**MEETING AGENDA
SESSION OF THE PLANNING ADVISORY BOARD
CITY OF KISSIMMEE
CITY HALL, COMMISSION CHAMBERS
101 CHURCH STREET, KISSIMMEE, FLORIDA 34741-5054
WEDNESDAY, OCTOBER 4, 2023 AT 6:00 PM**

Public Hearing - Conditional Use with Site Specific Redevelopment Plan to develop townhomes - 1040 June St - CU-23-0005

CU-23-0005
1040 June Street
Conditional Use/Site Specific Redevelopment Plan

PLAN NUMBER: CU-23-00005 1040 June St. Multifamily – 3rd Review

SITE PLAN
SCALE: 1"=20'-0"

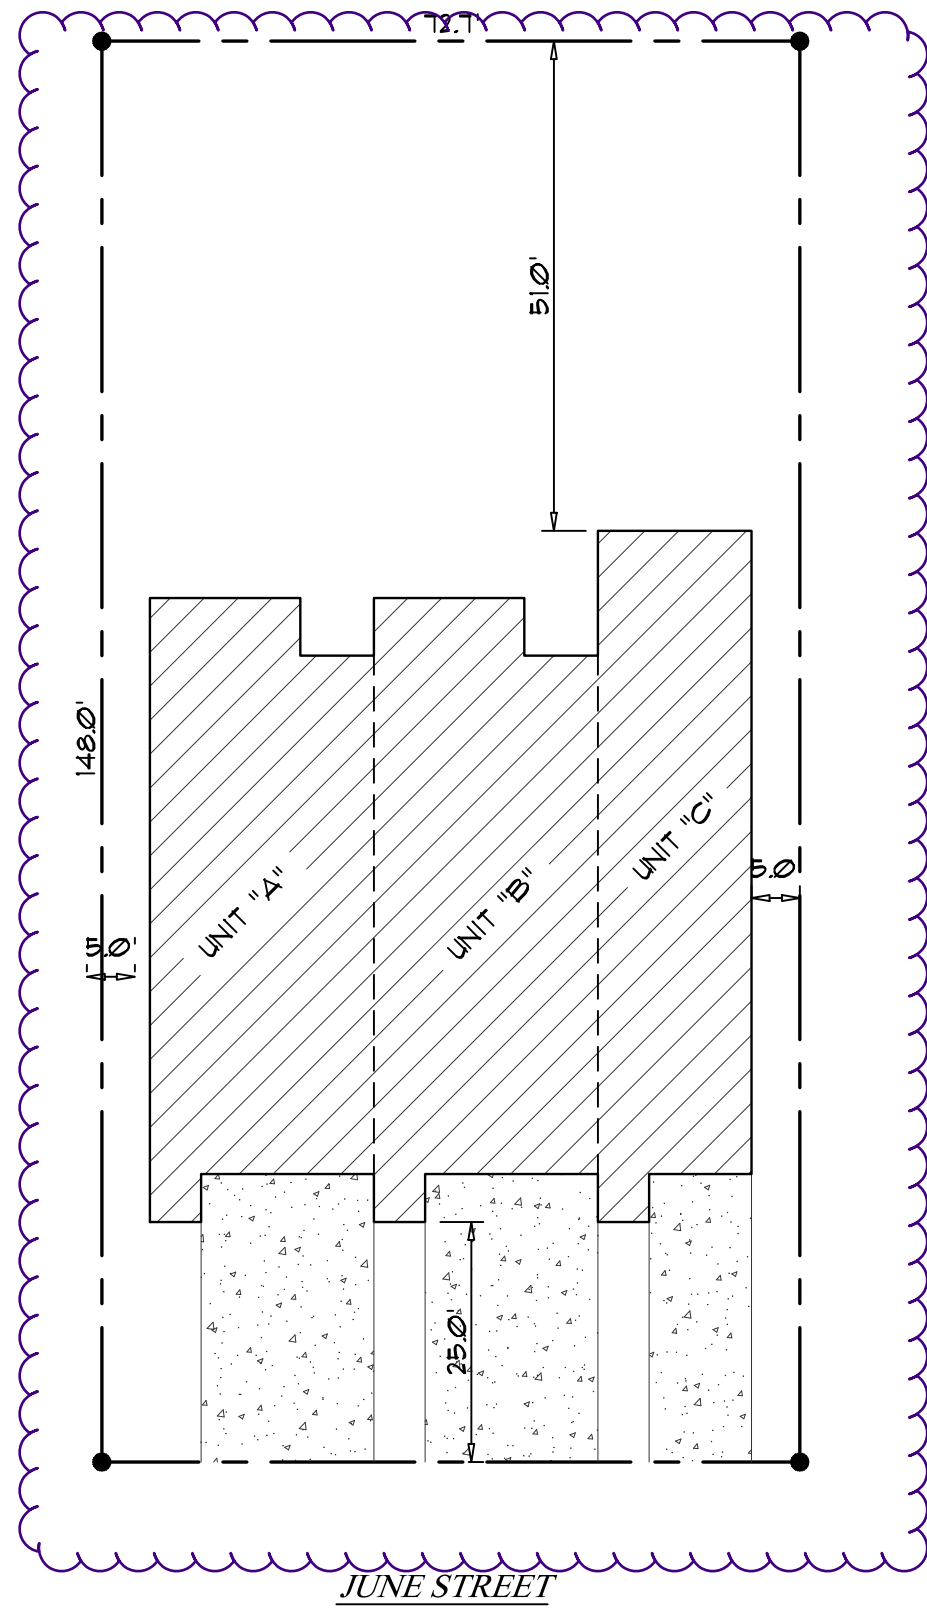
2. Three (3), fee simple townhomes are proposed and require Conditional Use (CU) approval from the Planning Advisory Board (PAB).
3. **Partially Addressed**: A Site Plan that includes information about the parking requirements, total sq. ft. of each unit, is needed to complete this review.

6. **Not addressed**: The front façade of each building shall have variable setbacks from the street to avoid monotonous façades. All of the units have the same setback. Revise. 14-6-43H

13. **Not addressed**: Landscaping shall be provided within the driveway separators. When the driveways of 2 adjacent units are located immediately next to each other, a separator planting strip, a minimum 30 inches in width, and extending 15 feet from the structure, shall be provided between the 2 adjacent driveway surfaces. Such planting strip shall be planted with shrubs and ground cover. 14-6-43J & 14-7-24A(3)d

- a. After the landscaped planting strip is added to separate the driveways, include **the width** of each individual driveway. For front loaded garages, driveways shall be a minimum of 8 feet in width and 18 feet in depth for a single vehicle, and have a garage door width of no more than 10 feet. 14-7-24A(3)a
14. **Not addressed**: Landscaping plans must be provided. Plant species, quantities, and specifications should be included on the landscaping plans.
15. **Not addressed**: How will trash be collected?

Include provided parking with construction plan review. Site Plan depicts 2 townhome units with a 2 car garage with driveway and a townhome unit with a single car garage with driveway. Each townhome unit requires a minimum of two (2) parking spaces per unit.

All architectural and design standards must be addressed with the construction plan submittal and review.

All landscaping standards must be addressed with the construction plan submittal and review.
